SUBJECT: RESUBMITTAL OF REQUEST FOR ADDITIONAL INFORMATION FOR THE
MODEL NO. LEUPA PACKAGE

Docket No. 71-3090

**Resubmittal of Request for Additional Information
Revalidation Review
Docket No. 71-3090
Model No. LEUPA**

Picture 27: Primary containment flange after tests

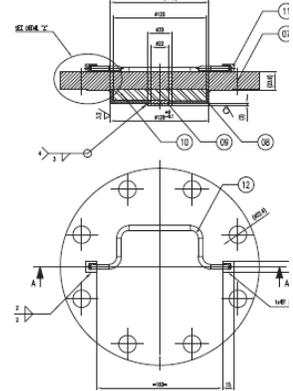
G-Sh-1. Revise the application's description of the "Primary Containment Lid/Flange."

The previous question regarding this item has not been adequately answered. The figure of concern is Picture 27 of the "Tests Final Report" document (shown here).

The picture above (i.e., figure) does not appear to be of or about the primary containment flange per the discussions and per the figure submitted in the RAI responses. It is not clear what this component is. Based on the figure submitted in the RAI responses, the metal object shown in the foreground of the picture, is not part of the packaging since that figure does not include it. It is also not clear that the design drawings include this metal object either. If this metal object in Picture 27 is the primary containment flange, then the submitted figure and the English version of the figure that is on page 27 of 30 of the Safety Report (Document No. 002 0908-LE00-3BEIN-023-A) (see cut out of figure from Safety Report page 27 of 30 below) and the design drawings (see a cut out of Drawing No. 00B 0908-LE01-3AEIN-005-A below) are not correct and must be fixed because these show the primary containment flange as a solid lid with a handle and a cadmium component (whereas this Picture 27 has a large hole in the

middle of the flange). The object with a handle in Picture 27 appears to be the top most of the four inner cans that are loaded into the package.
